TECHNICAL SERVICE BULLETIN

Bulletin Number: DC-2205

**Affected Model(s): Bare 282396, 3:1 and 84933, 5:1 Fluid Pumps
(Associated Configured Models)**

Subject: 230001 Fluid Piston Replacement Kit

MODEL 230001 Piston Replacement Kit

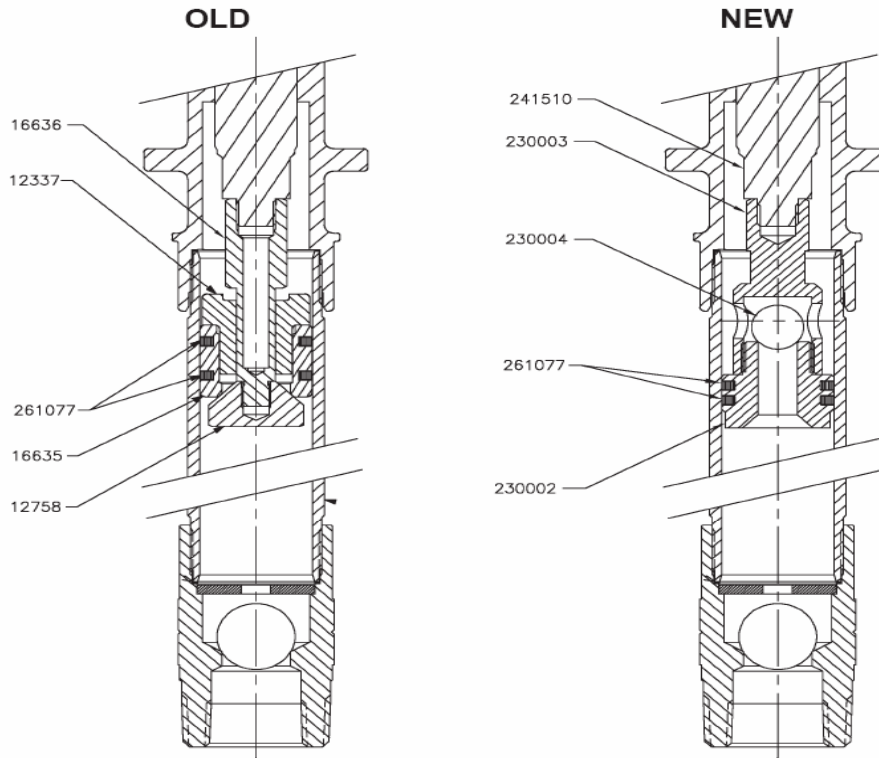
We are pleased to announce an enhanced fluid piston assembly for our 282396 (3:1) and 84933 (5:1) bare pumps and all associated Series 25 and 40 models. The change is the result of ongoing research by our engineering department to provide enhanced performance of the pump assembly and increased reliability of the piston assembly. The major change to be recognized is that the old style plastic piston has been replaced by a steel unit. Our research determined that the plastic piston was more apt to swell or show other effects of pumping some more aggressive fluids. The other major enhancement is the replacement of the old style "check seat" (12758) with a more positive sealing "check ball and seat" configuration (230002 and 230003). A copy of our new service page, Section A6, Page 64 (form 402084) is attached for your review.

- Remove the 241511 lower tube,
- Remove the 12758 piston seat,
- Remove the 16635 plastic piston,
- Remove the 12337 spring stop,
- Remove the 16636 connecting rod

- Replace the 16636 connecting rod with the 230003 piston connector,
- Install the 230004 steel ball and 230002 piston assembly,
- Install new 261077 piston packings (same in both assemblies).
- Re-install 241511 lower tube.

THE PREVIOUS PISTON ASSEMBLY CONSISTING OF PARTS 12768, 16636, 12337 AND 16635 WITH PACKINGS 261077 WILL BE REPLACED BY PISTON REPLACEMENT KIT PN 230001 WHICH INCLUDES 230004, 230003 AND 230002 WITH PACKINGS 261077.

Please note: Loctite 242 should be applied on the threads of the 230003 and 230002 prior to assembly and they should be tightened to 10 ft. lbs.

COMPONENT PART NO.	COMPONENT PART NO.	ASSOCIATED TORQUE (+/-1%)	LOCTITE REQ'D.
241510	230003	10 FT LBS	ONE DROP #242
230003	230002	10 FT LBS	ONE DROP #242
